Commission of Architectural Review

1. COA-131665-2023	Final Review	Meeting Date: 6/27/2023
Applicant/Petitioner	Amanda Meyer	
Project Description	Installation of a 6' by 10' prefabricated storage shed in a rear yard.	
Project Location		
Address: 2017 Venable Street		
Historic District: Union Hill		
<p>High-Level Details:</p> <ul style="list-style-type: none"> • The shed will be 7' tall. • The shed will be inset 8' from the rear of the property and 1'6" from the east side of the fence. • The proposed shed will be constructed in the 'Tall Barn' style. 		
Staff Recommendation	Approval	
Staff Contact	Annie Delaroderie, anne.delaroderie@rva.gov , 804-646-6335	
Previous Reviews	None	
Conditions for Approval	<p>Staff recommends:</p> <ul style="list-style-type: none"> • that the shed be screened from view, behind the existing rear fence.

Figure 5. View of the rear yard, behind 2017 Venable Street, facing south.

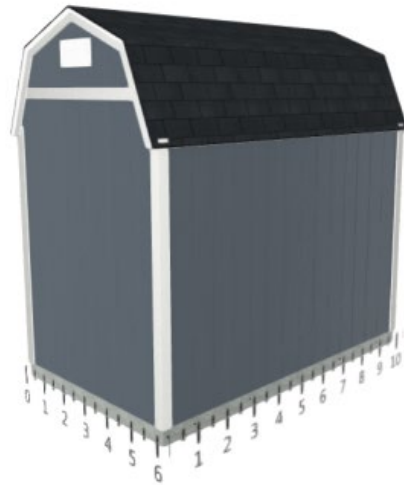
New Construction: Residential Outbuildings, page 51.	<i>2. Newly constructed outbuildings should respect the siting, massing, roof profiles, materials, and colors of existing outbuildings in the neighborhood.</i>	The proposed shed will be built of pressure treated wood and the roof will have three-tab shingles. The color of the shed will be dark grey, similar to the primary building.
New Construction: Residential Outbuildings, page 51.	<i>3. New outbuildings should be smaller than the main residence and be located to the rear and/or side of the property to emphasize that they are secondary structures.</i>	The new shed will be located toward the back of the rear yard, and eight feet from the southern fence line.
New Construction: Residential Outbuildings, page 51.	<i>4. Prefabricated yard structures are discouraged. Screening will be considered as a mitigating factor for the installation of these structures. However prefabricated structures will still be reviewed for compatibility using the listed criteria.</i>	The new shed will be screened with the existing fence. This proposed building will not detract from the primary building. The shed will be 7' tall and the rear fence appears to be a 6' wooden fence. <u>Staff recommends that the shed be screened from view, behind the existing rear fence.</u>
